RE: Penn Shop Road Property
#A514179
Perc Plat

RE: Percolation Certification Plan (A514179)
Purpose: Sand Mound for a Lot of Record
Property ID: Former Zeigler Property
Penn Shop Road @ Rte 27
Tax Map 6, Parcel 10

PENN SHOP ROAD PROPERTY

PERC CERTIFICATION PLAT

SM2 & SM3

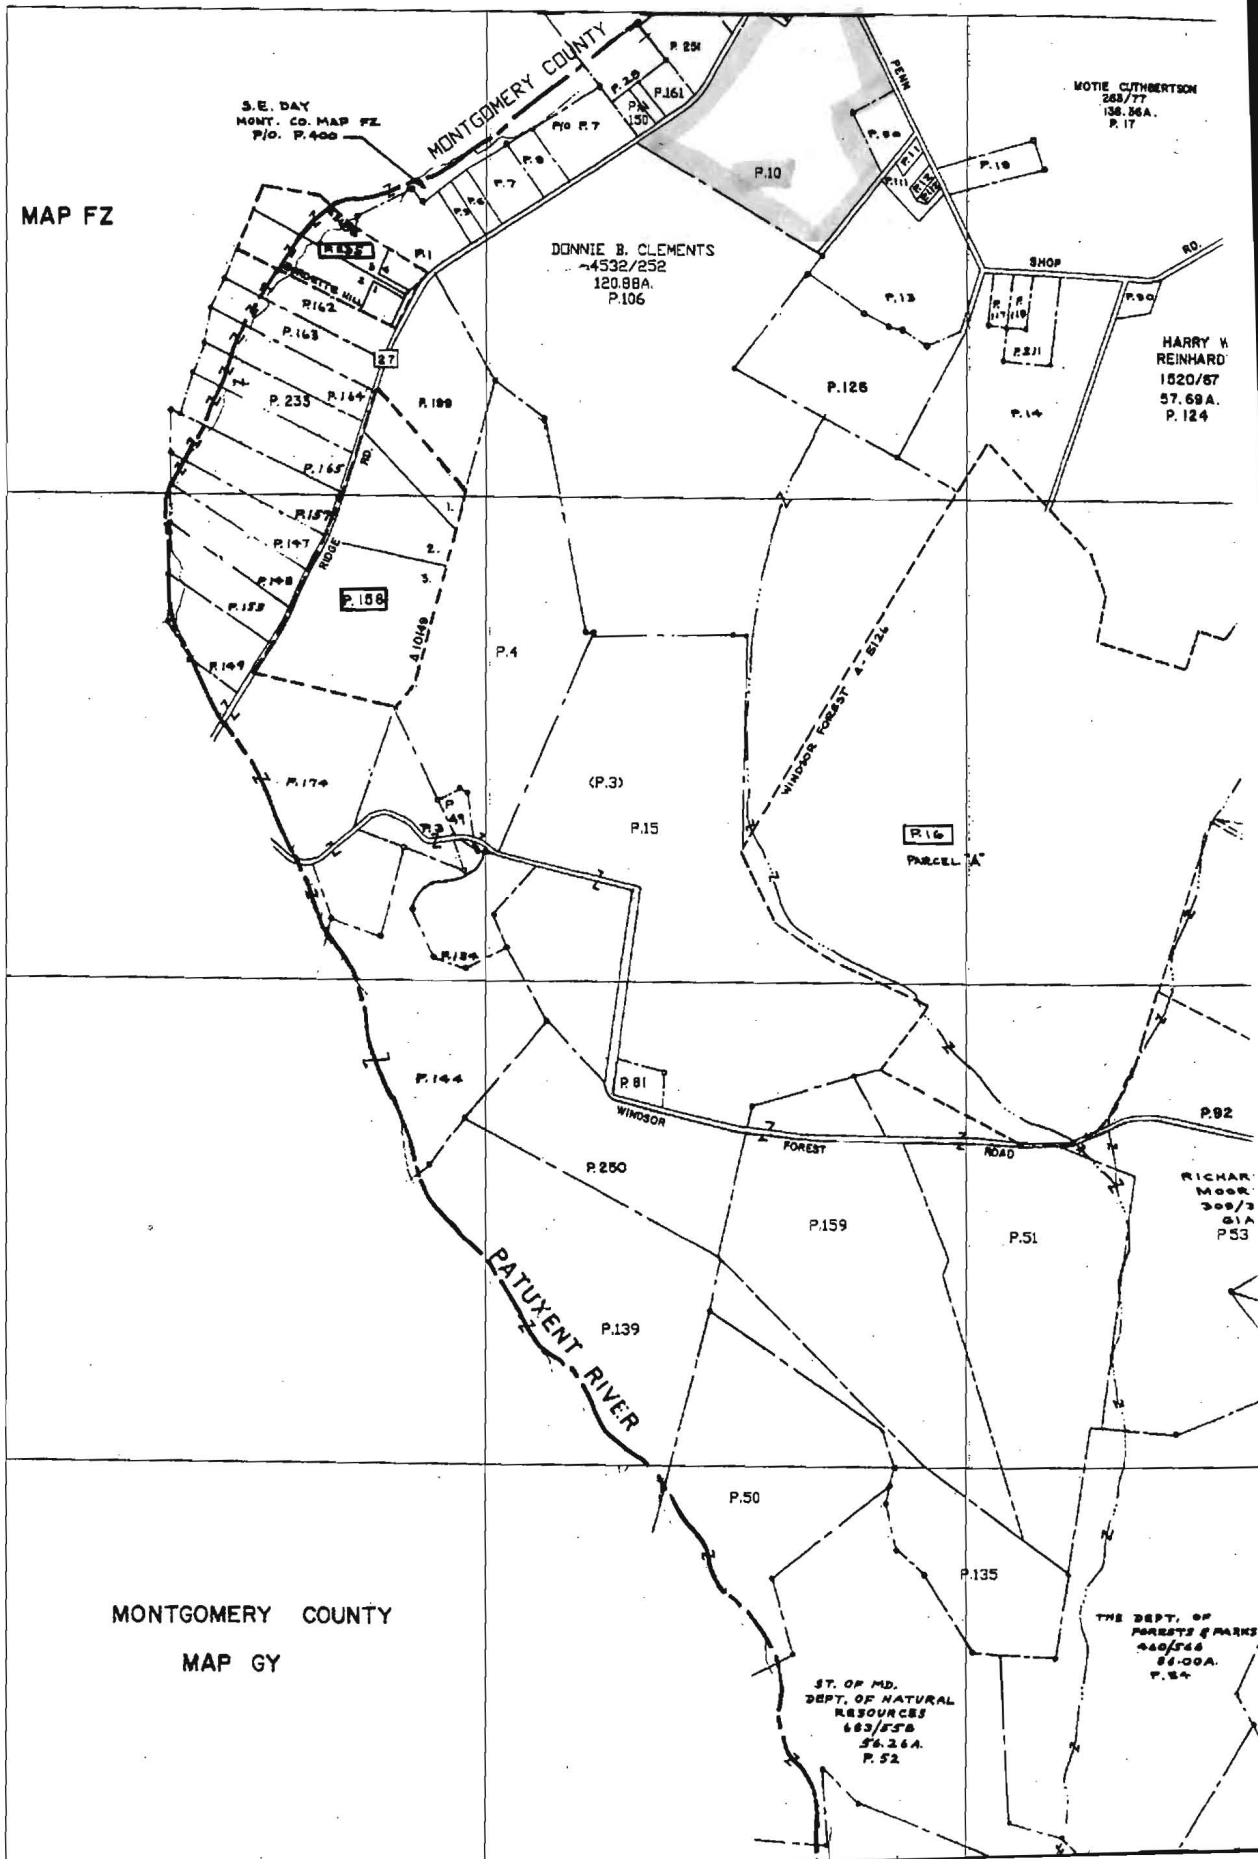
Similar to #1/2
footprint on plan
are all OK for
perc cert Plan
3/8/01 RVP

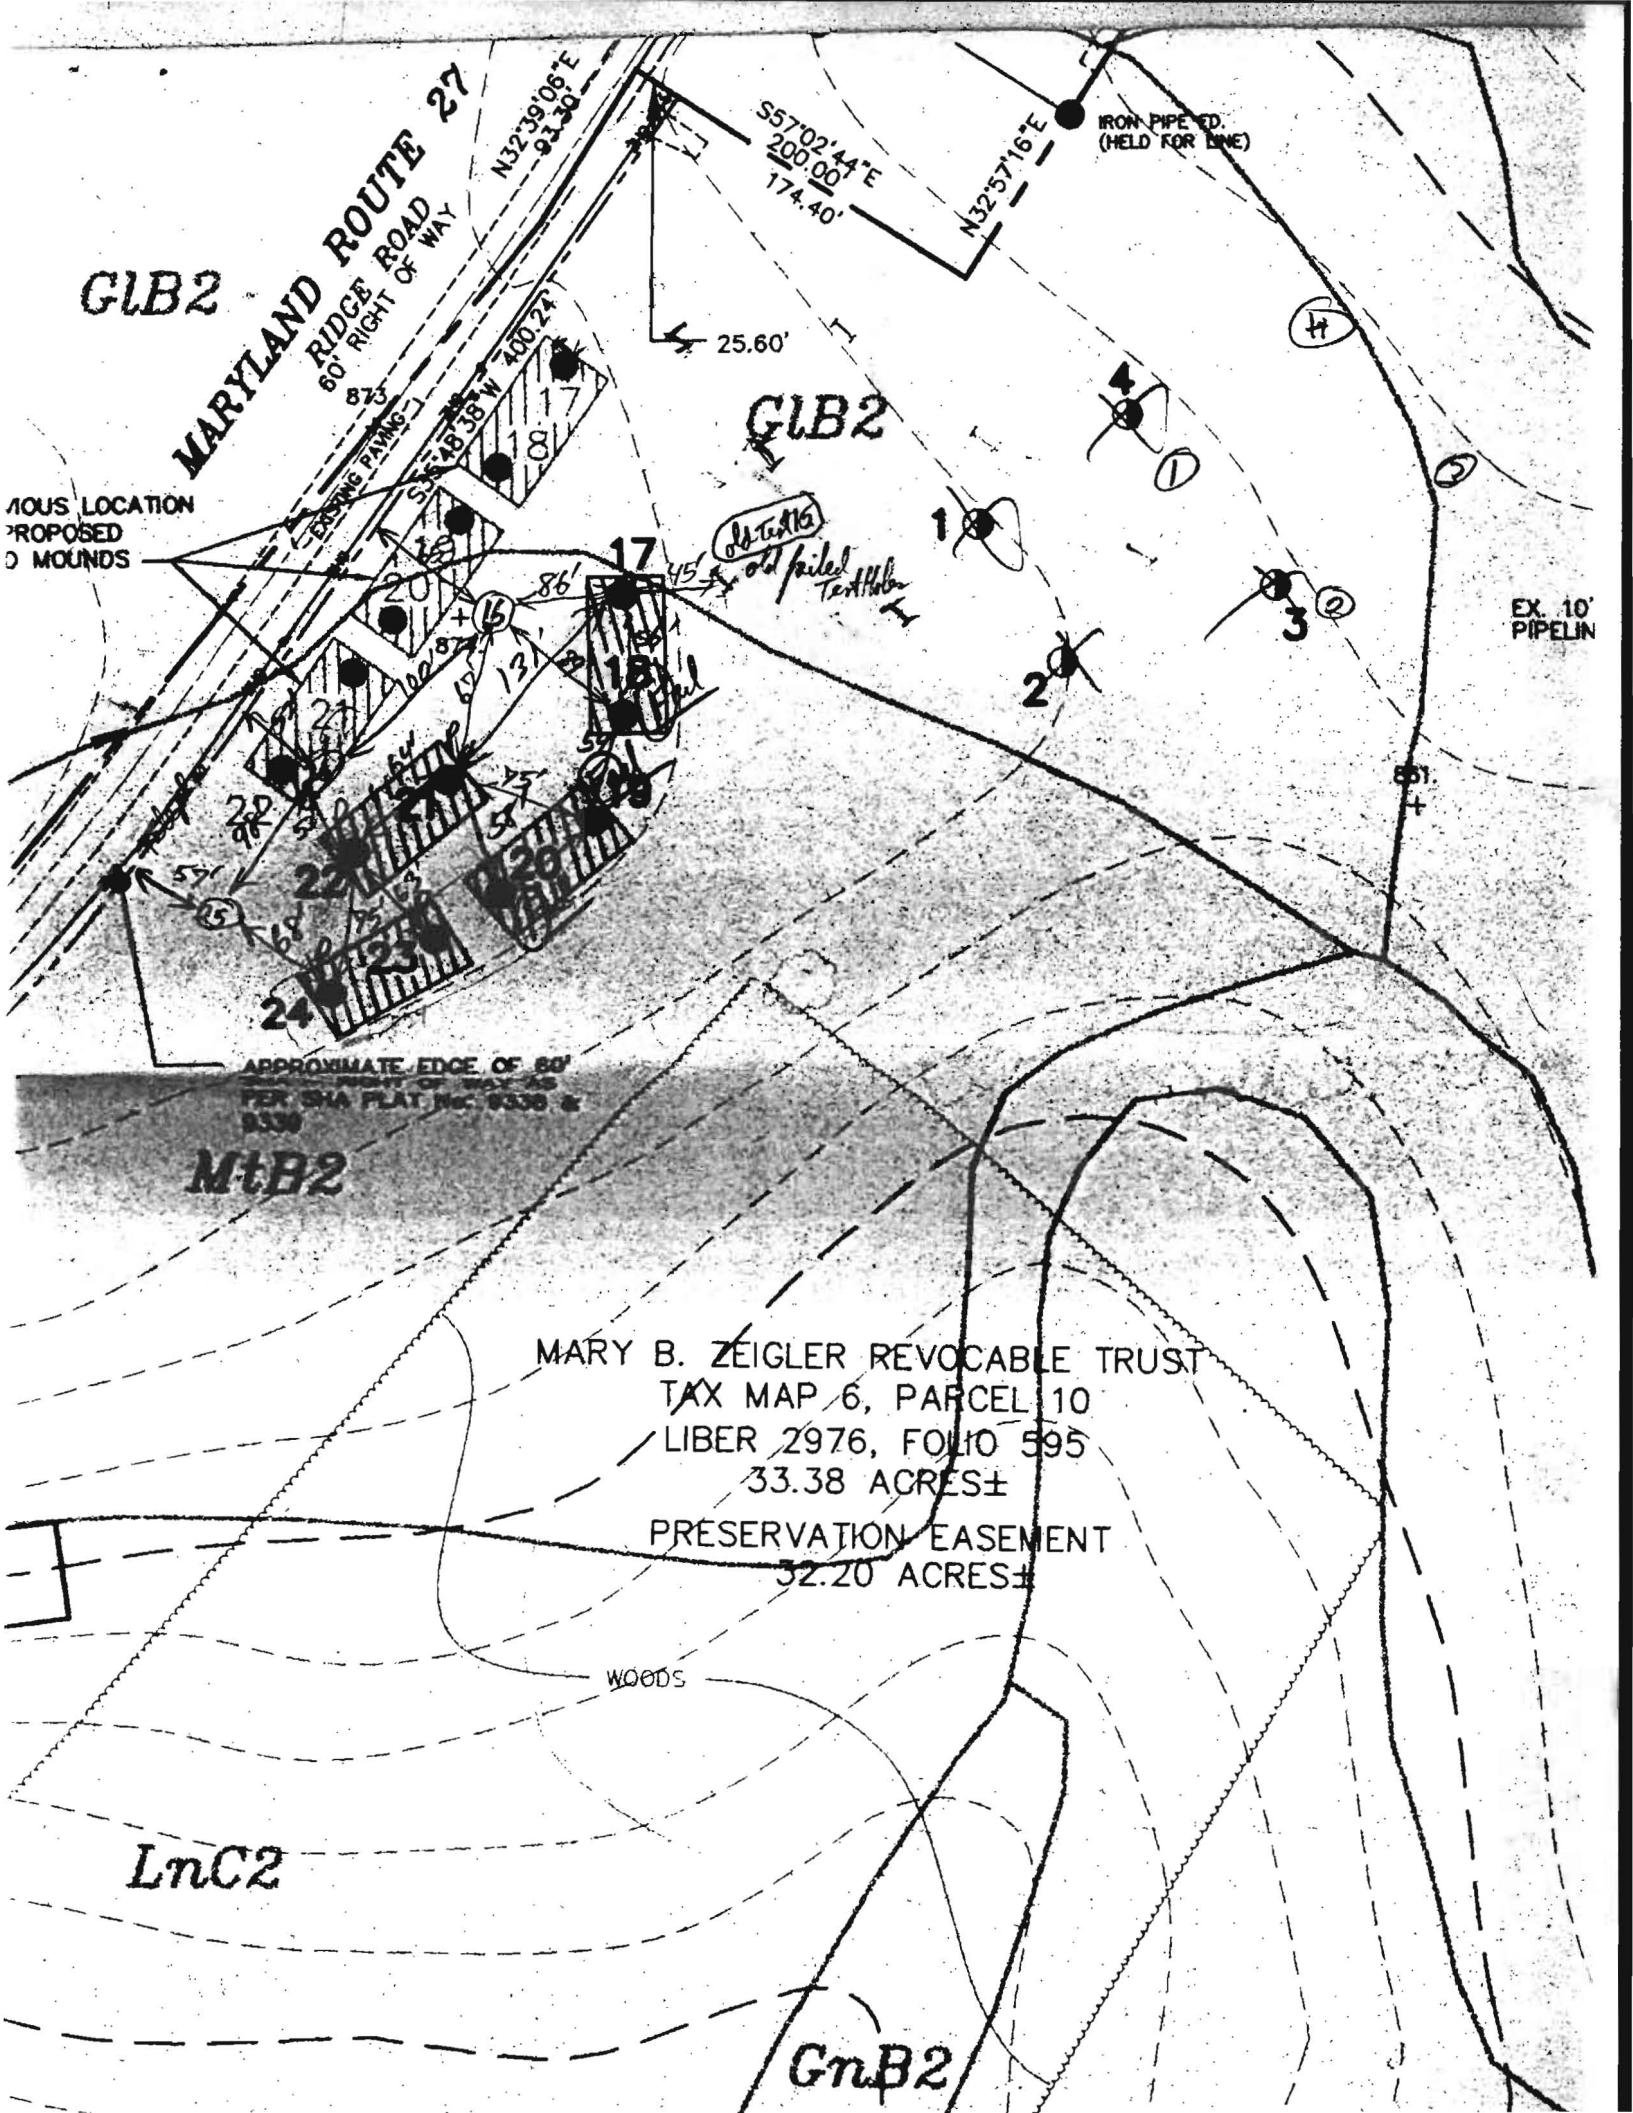
GIB2
Proposal is Not acceptable
Proposal does Not
show proper concern for
optimal orientation of Sand Nests
and No other preliminary testing
has been performed. They were instructed
to do a wide search for sites with
Non Linguae Soils first. **APPRO 1/13/00**
Need to do preliminary before
Scheduling S.M. infillback tests
